**Re: GCC Rio Grande, Inc. - DRMS Permit No. M-2002-004, Revision No. AM-1
Exceedance of Groundwater Numeric Protection Levels**

GEOLOGIC REPORT AND SUBMITTAL

SUBJECT: A submittal in response to the letter by Division of Reclamation, Mining and Safety (DRMS), dated 29 November 2012 regarding: Pueblo Cement Plant and Limestone Quarry, Permit No. M-2002-004, Exceedance of Groundwater Numeric Protection Levels.

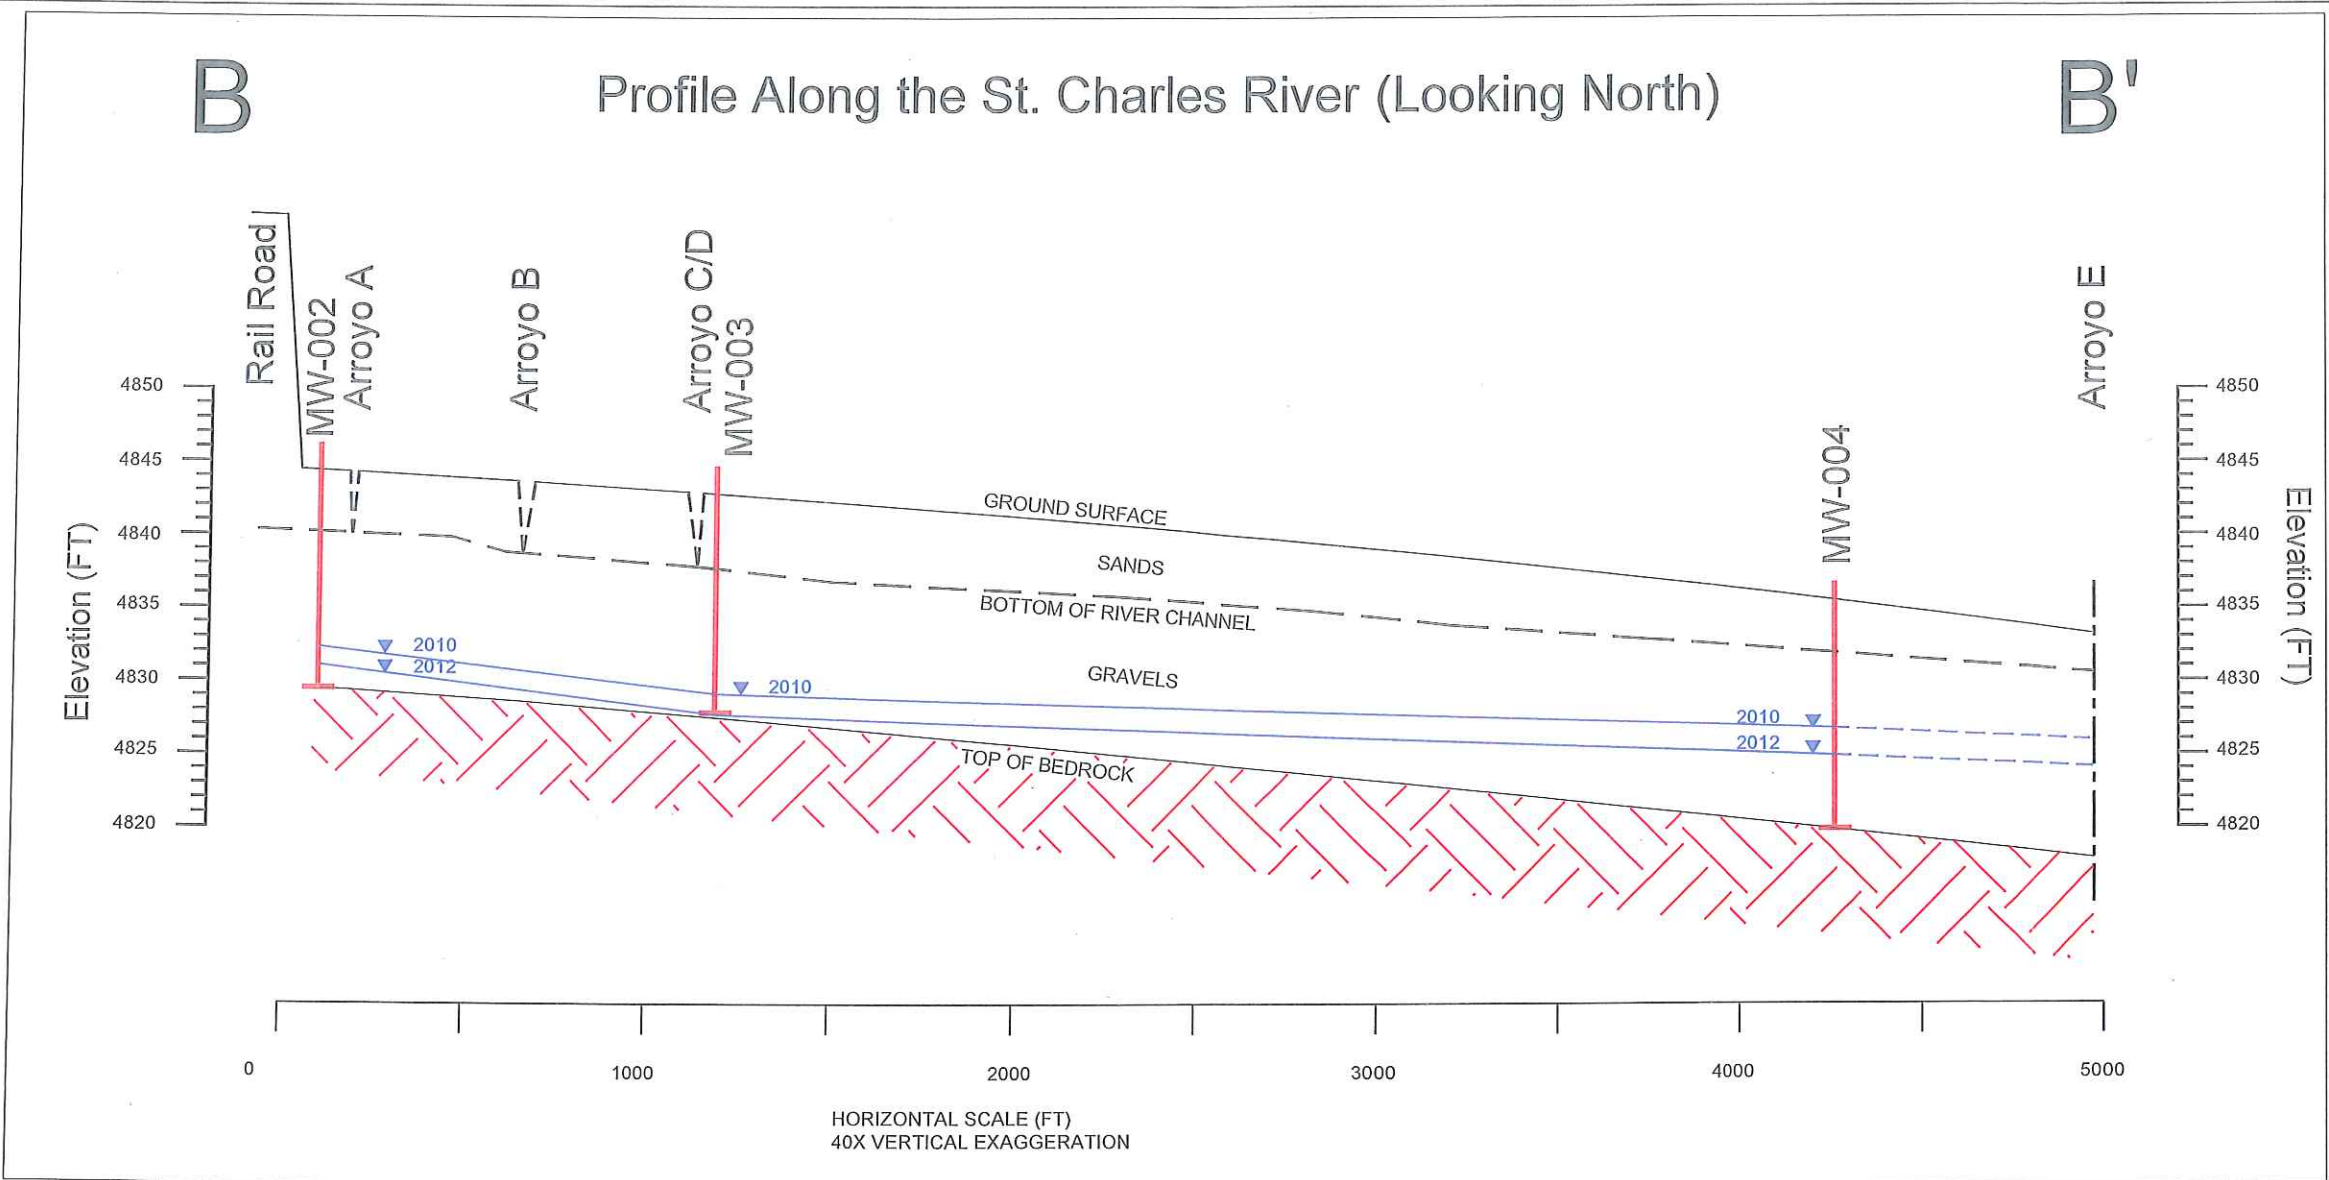
d) *Shows the completion intervals of MW-002, MW-003, and MW-004 (project into cross-section)*

e) *Shows the water levels of the wells in the 3rd quarter 2012*

Response: Figure G5 presents a cross section of the three alluvial monitoring wells, looking north across the St. Charles River profile. Water levels from October 2010 and September 2012 are shown in the section. Well MW-003 was dry in September 2012 and December 2012.

Response: Water levels are shown in cross section Figure G-5 for the third quarter 2012 monitoring event (September 26, 2012), and for the third quarter 2010 event. Well MW-003 was dry in the third quarter 2012. Well MW-003 had approximately 3 inches of water in the second quarter 2012 monitoring event (June 21, 2012), just before the well went dry.
